CALIFORNIA COASTAL COMMISSION

STAFF REPORT AND RECOMMENDATION**ON CONSISTENCY DETERMINATION**

Consistency Determination No.	CD-084-99
Staff:	LJS-SF
File Date:	8/6/99
45th Day:	9/20/99
60th Day:	Extended to 10/18/99
Commission Meeting:	10/13/99

FEDERAL AGENCY: **CORPS OF ENGINEERS**

EXHIBIT NO. 3
APPLICATION NO.
CD-84-99
California Coastal Commission

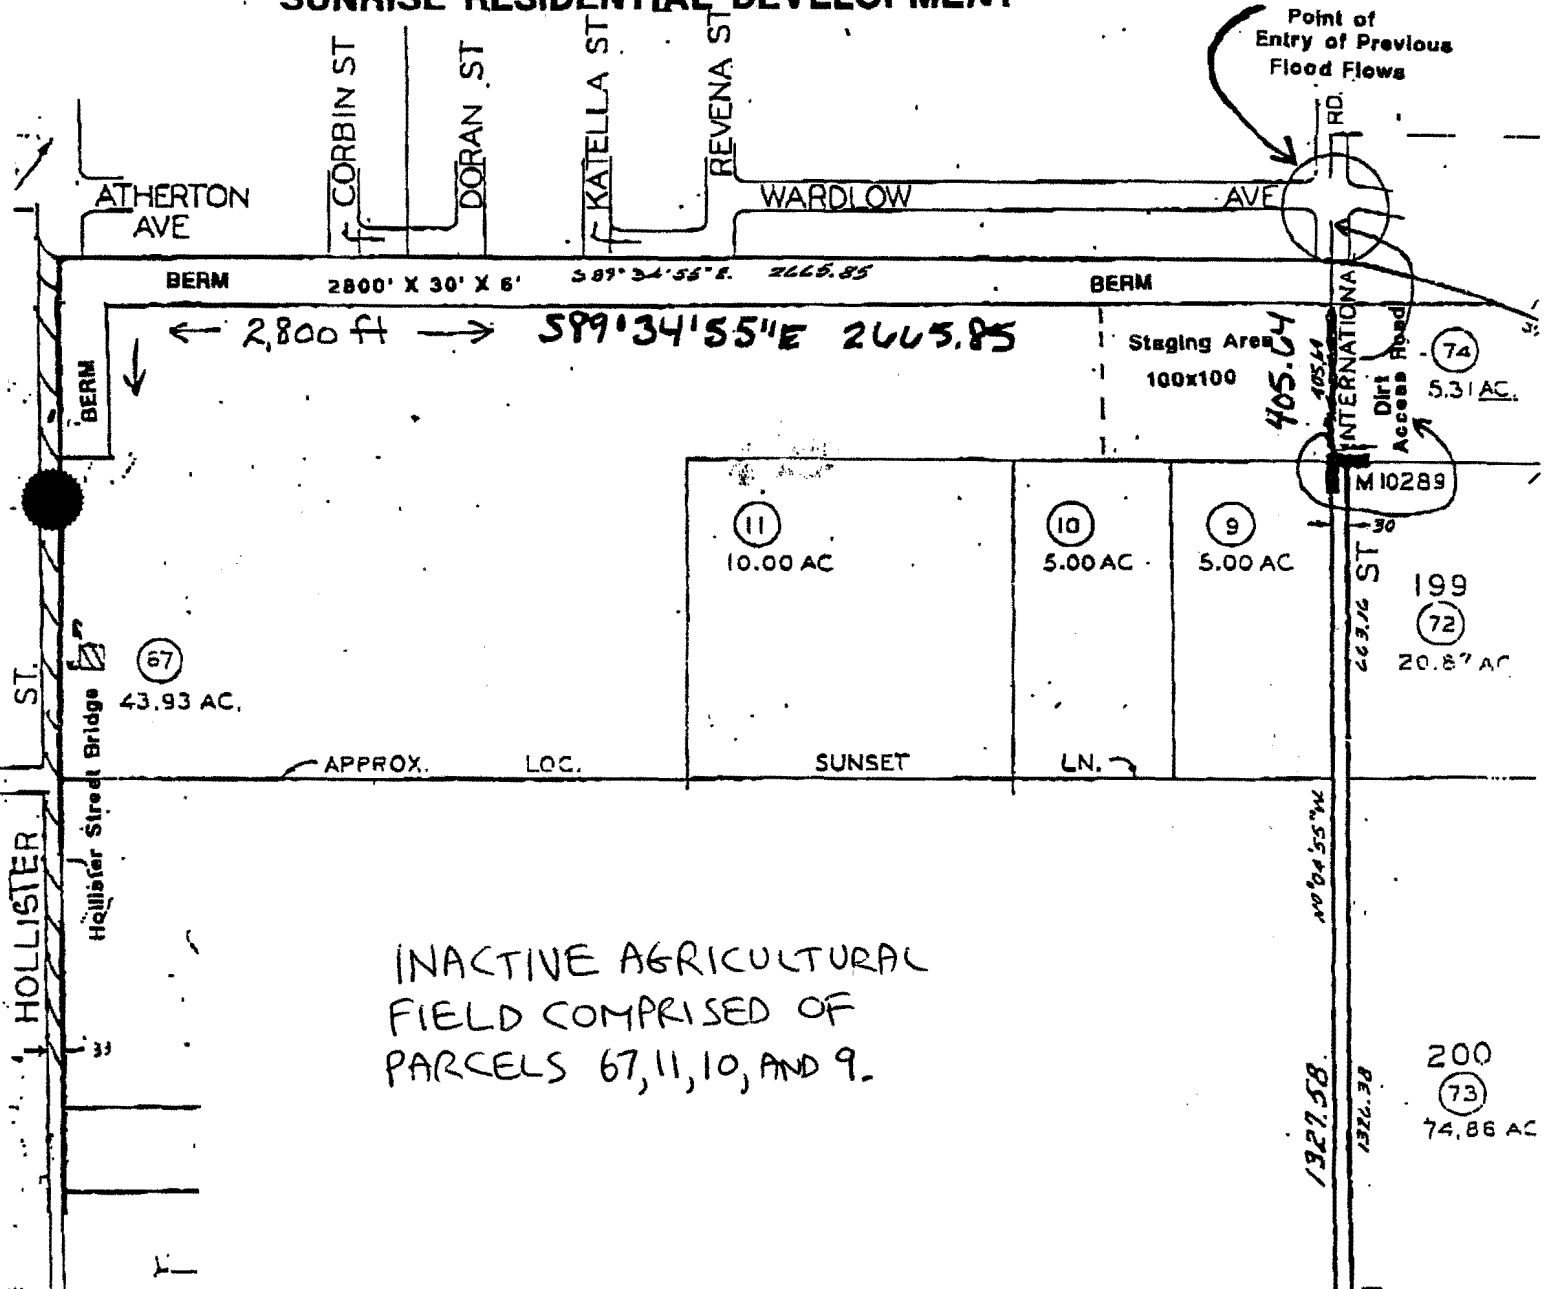
The proposed berm would be constructed along an existing, south-facing, four-foot-high earthen embankment that separates a currently inactive agricultural field and the Sunrise residential development. The 2,800-foot-long, 30-foot-wide (at the base) earthen berm would be constructed primarily along the northern perimeter of the field; however, at the northwest corner

the berm would turn south for approximately 300 feet until intersecting existing high ground along Hollister Street (Exhibit 3). The berm would have a total footprint of two acres and be situated on prime agricultural soil. The presence of the berm would reduce the amount of acreage available for future agricultural operations on the 64-acre field by three percent (two acres).

The Corps examined alternatives to the berm that would not use agricultural lands or a reduced amount of land and determined that these alternatives are infeasible due to economic or environmental factors, or both. However, the Corps did not examine the construction of a floodwall instead of the proposed berm. The proposed berm requires a 2:1 slope and to achieve the necessary flood protection. It is this slope that results in a loss of prime agricultural soils. On the other hand, a floodwall would be vertical and could be constructed without a loss of prime agricultural soils. Therefore, the proposed berm is inconsistent with Section 30241's requirement to maintain the maximum amount of prime agricultural land. Additionally, the proposed project, which provides protection for an urban land use, is an inconsistent conversion of prime agricultural land. Section 30241(d) requires the development of lands not suited for agriculture prior to conversion of agricultural land. Since the vertical wall could be constructed entirely on non-agricultural lands, the proposed berm would convert agricultural land unnecessarily. Therefore, the proposed project does not meet the requirement of using non-agricultural land prior to converting agricultural land.

In conclusion, the Commission finds that the proposed flood control berm has not been designed to minimize agricultural impacts and is, therefore, inconsistent with the agricultural protection

1. Design a floodwall to provide protection to the adjacent subdivision.
